ADDENDUM 01

Contract # 25-S-01

Dated: January 9, 2026

FRESNO COUNTY
Department of Public Works and Planning
Development Services and Capital Projects Division
m/a 2220 Tulare Street, Eighth Floor
Fresno, CA 93721 (559) 600-4536
zkhan@fresnocountyca.gov

6. REFER TO SHEET A2.01.01 & A2.02.01:

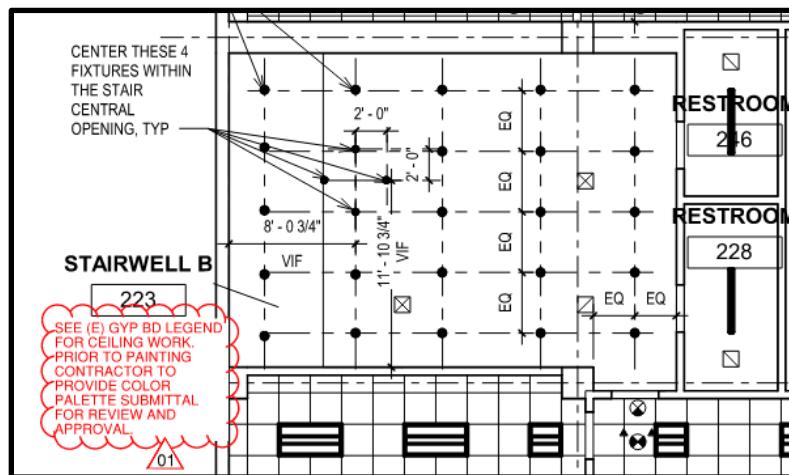
6.1 DELETE GENERAL NOTE 5:

5. PER TERENCE ECKMAN, THE LIBRARY HAS ITS OWN STAFF AND THEY WILL DO THE PAINTING.

6.2 REPLACE WITH GENERAL NOTE 5:

5. THE LIBRARY STAFF WILL ONLY PERFORM MINOR TOUCH-UP PAINTING. REFER TO SHEET A1.01.01 GENERAL NOTE 39.

16. REFER TO SHEET E3.02.02:

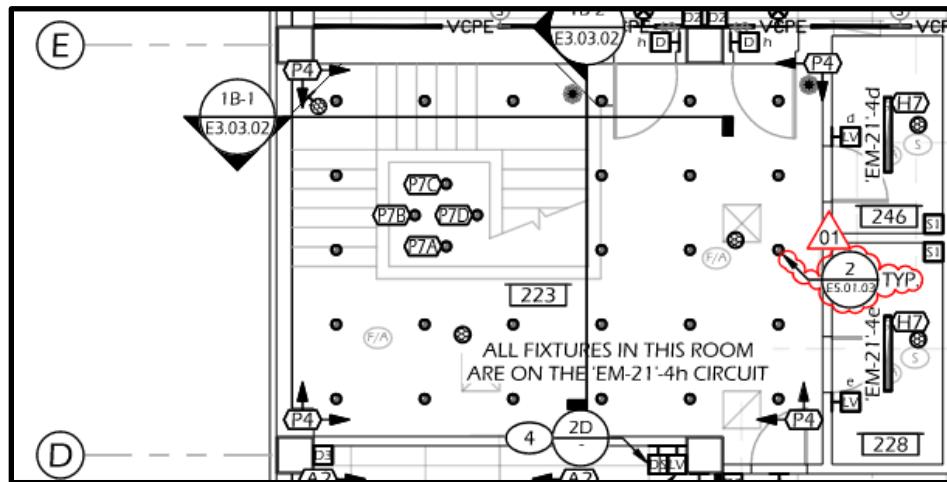
16.2 ADD THE FOLLOWING REFERENCE DETAIL (2/E5.01.03) TO THE LIGHT FIXTURES IN ROOM 223 INDICATED WITHIN THE REVISION CLOUD.

17. REFER TO SHEET E4.00.01:

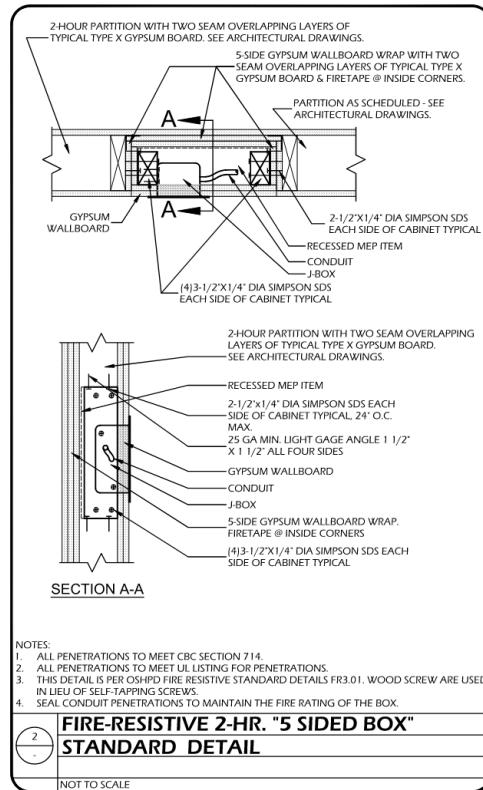
17.1 CHANGE TITLE TO DETAIL DESIGNATOR 1/E4.00.01 TO
"BASEMENT LEVEL FIRE ALARM FLOOR PLAN"

17.2 STRIKE/DELETE VERBIAGE 'THIS SHEET FOR REFERENCE
ONLY'. REFER TO PLAN SHEET FOR FIRE ALARM SCOPE OF WORK.
